GENERAL APPLICATION

Explanation of Request: Site Plan approval to allow for the redevelopment of the Property to a mixed-use project consisting of 58-multifamily units and general office use.

Deandrea Moise, Planner
City of Hollywood
Department of Development Services

Thank you for reviewing this application for the Oak 58 (fka: Hollywood House) mixed-use project. Included in this memorandum, please find the applicant's response to staff's comments in **bold** text.

SP1

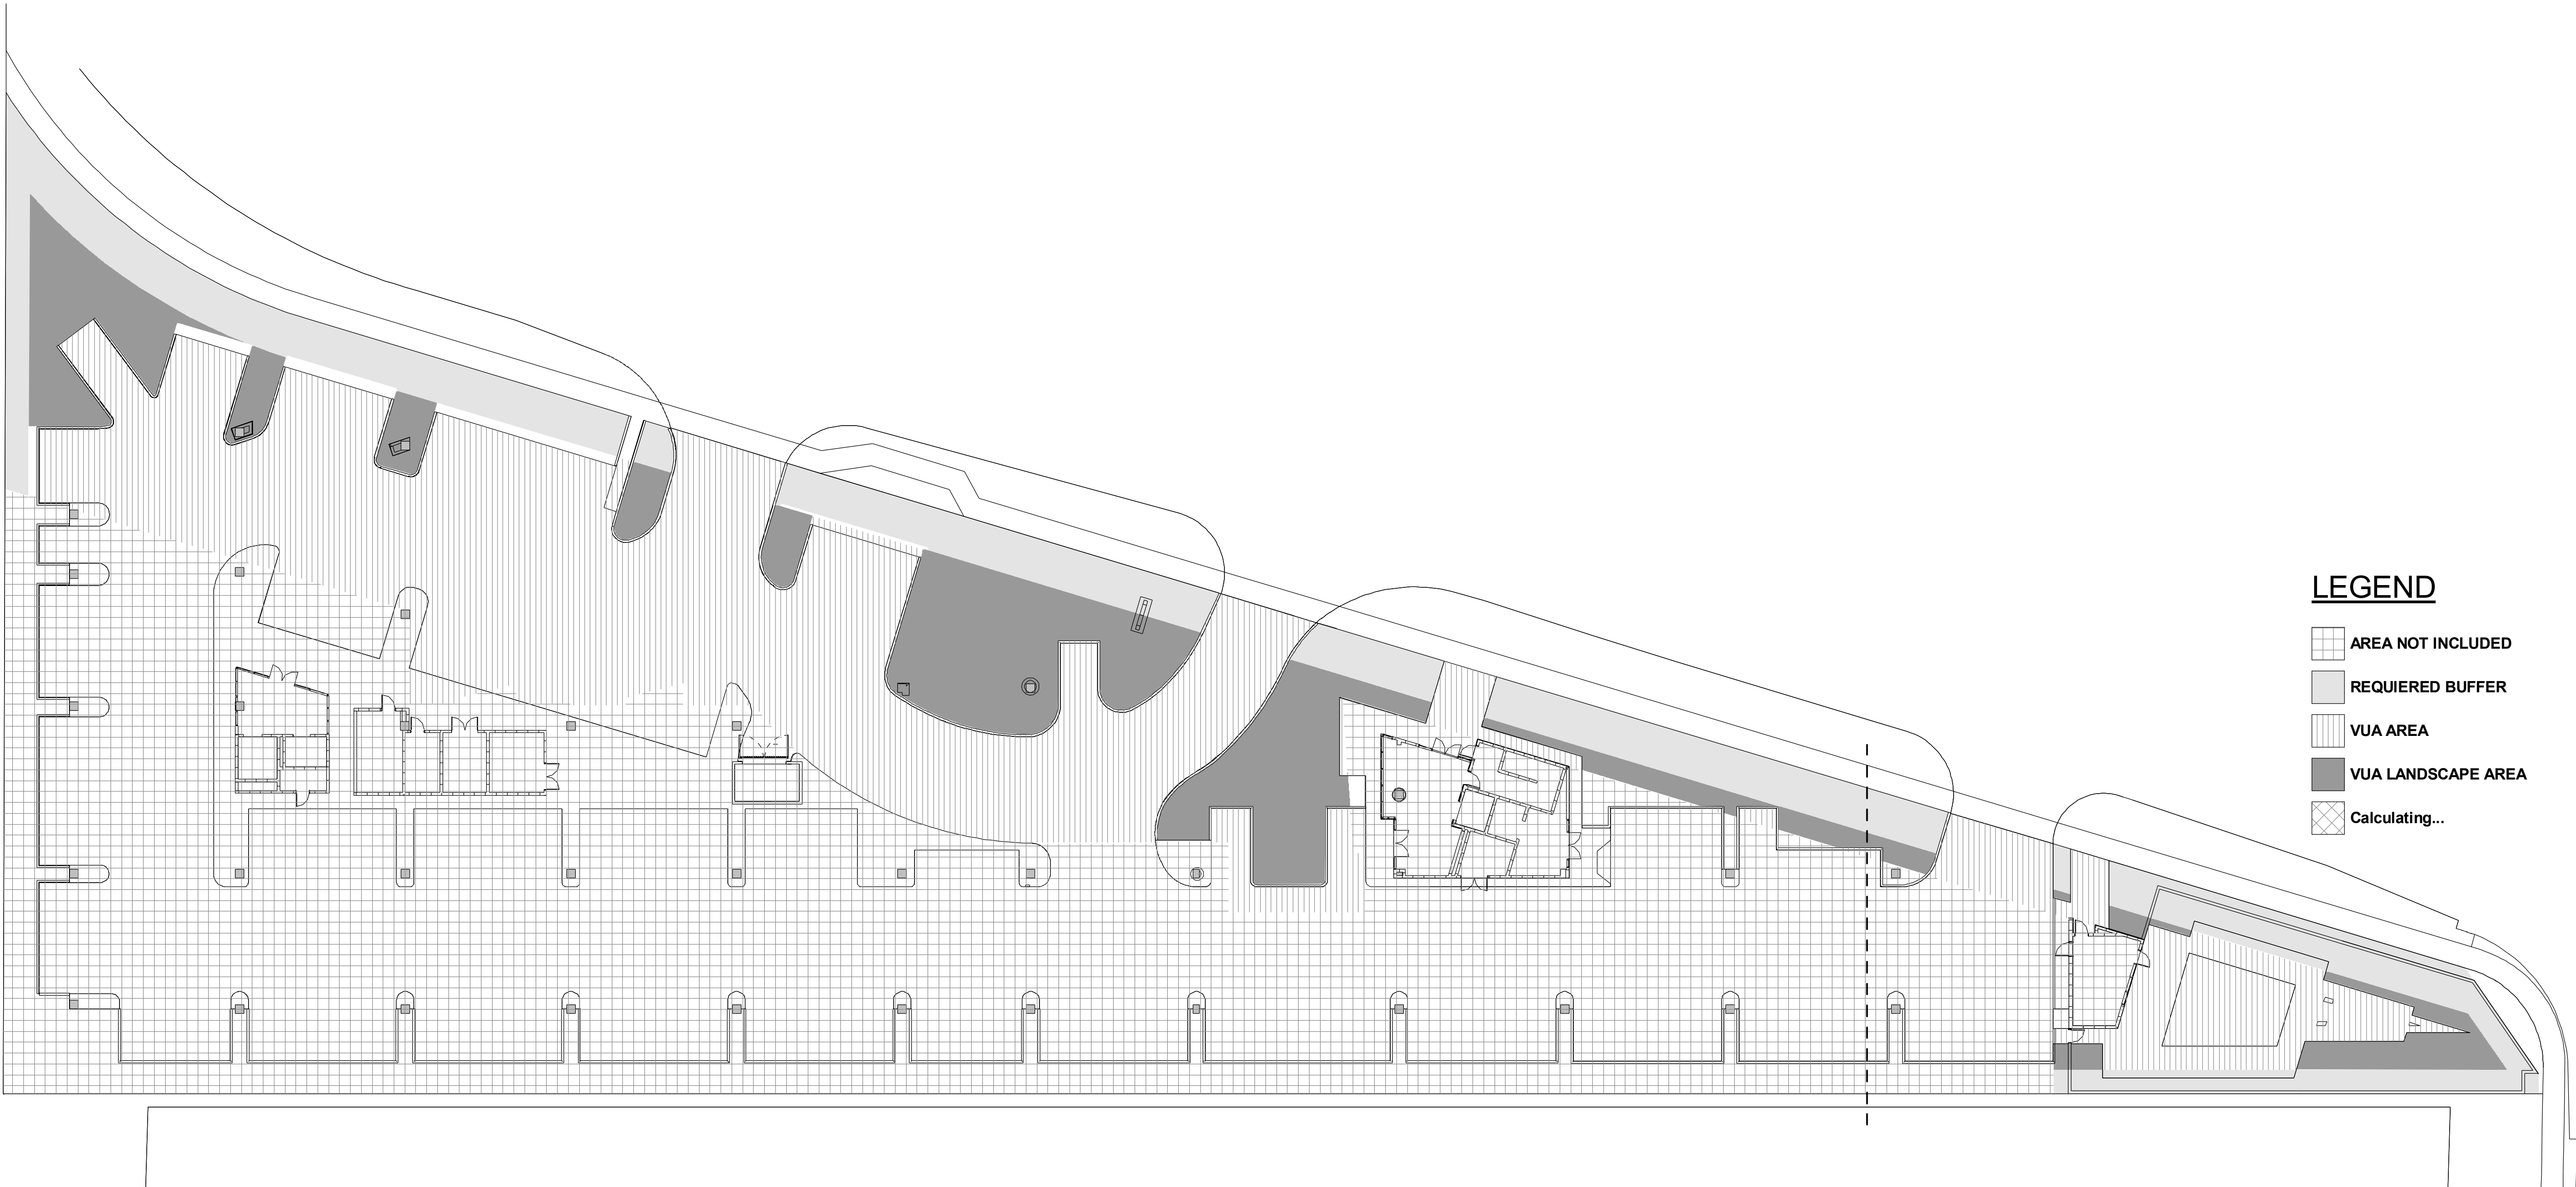
4. Revise tabular data to be clear on what is required and what is provided. Ensure that all minimums required are accurate as outlined in the code.

5. Various inconsistencies were identified in the Parking Reduction strategies. Revise accordingly.

6. Provide breakdown of building areas and square footage for each floor.

3. Illustrate two foot overhang for parking on plans. Overhang shall not be used in calculation for pervious area.

7. Balconies on second floor on south façade are not illustrated on site plan and shall be dimensioned from property line.

1. Note on site plan shall be revised to state that maximum foot-candle at all property lines shall be 0.5.

5. Sheet SP1, revise hatching for the material to be used for sidewalks, the Planting Area hatch was used. Provide for 6" thick concrete sidewalk. Complied.

8. Sheet SP1, parking stalls south of the Trash Room does not meet minimum parking stall width of 8.5'. Complied.

9. Sheet SP1, please provide width for the parallel parking. Please provide dimension for the parallel parking adjacent to the circular drive on Sheet SP1.

Response: The Tabular Data on Sheet SP1 has been updated.

Response: The Parking reduction strategy numbers have been updated on Sheet SP1.

Response: The building area breakdown and square footage of each floor has been provided on Sheet SP1.

Response: The two foot vehicle overhang has been provided on sheet SP1.

Response: A note indicating the maximum foot-candle level has been provided on the plans. See the notes box on Sheet SP1.

Response: The parallel parking dimensions have been added to Sheet SP1.

2
VUA
VUA AREAS PLAN
1" = 20'-0"

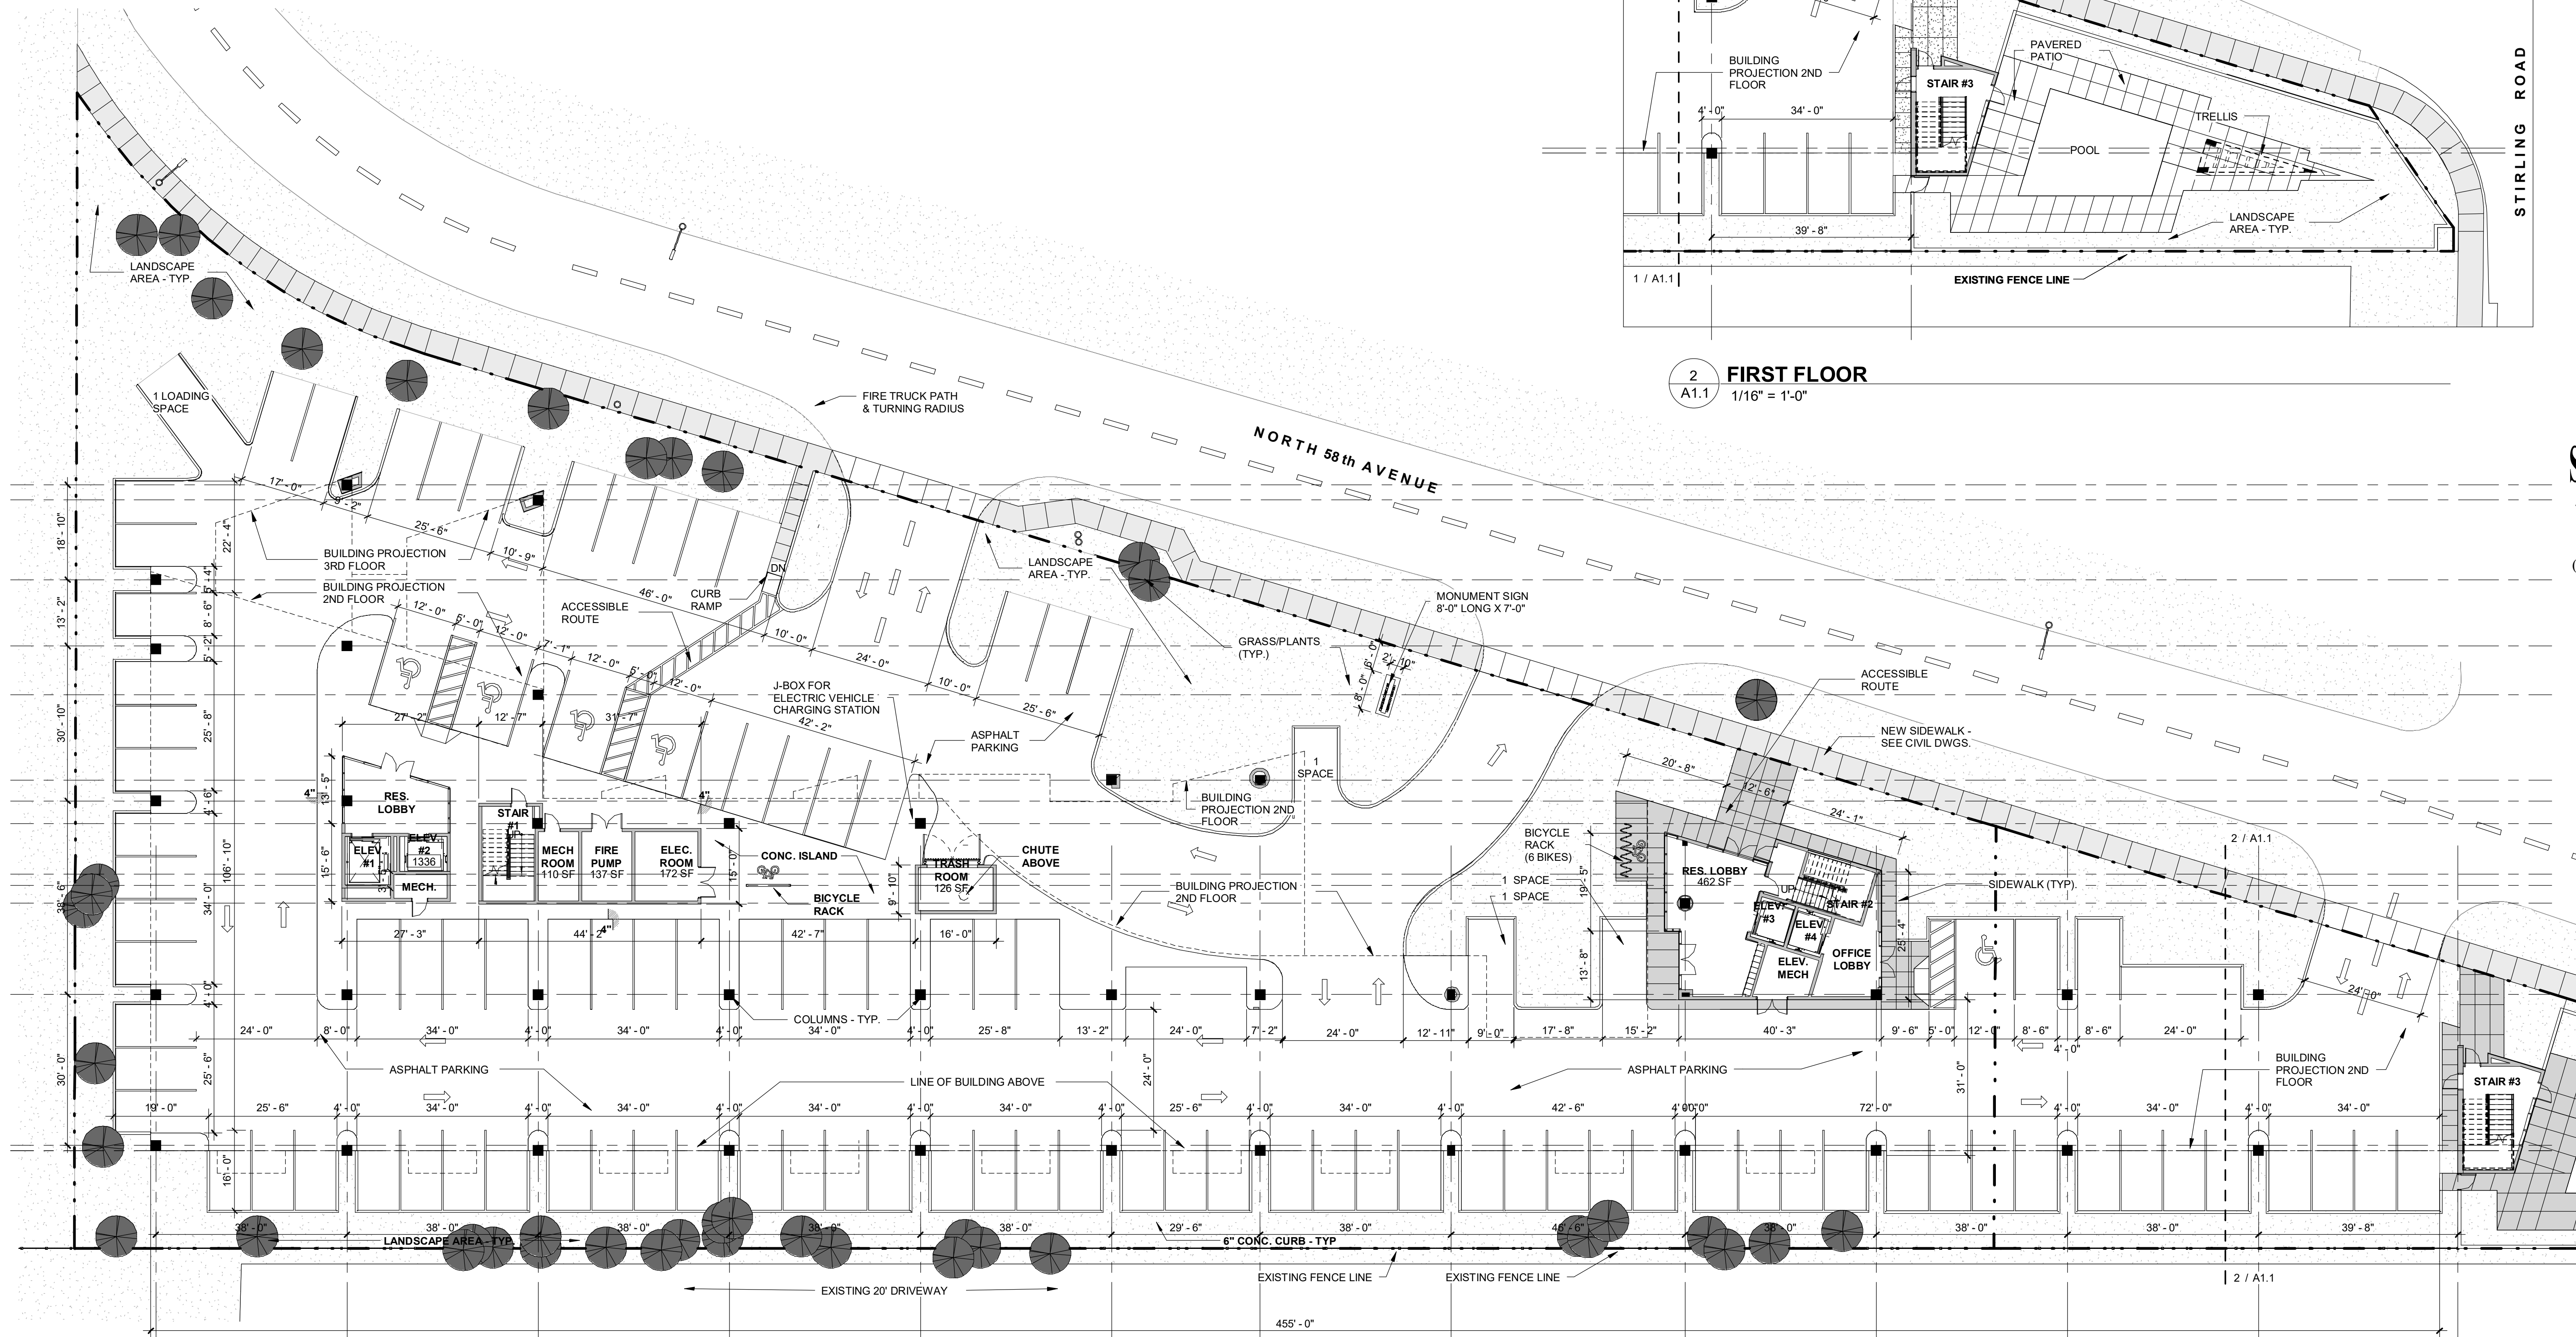
4. Provide separate Vehicular Use Area diagram illustrating compliance with VUA landscape requirements and at grade parking requirements.

Response: The VUA diagram drawing has been added. See sheet VUA.
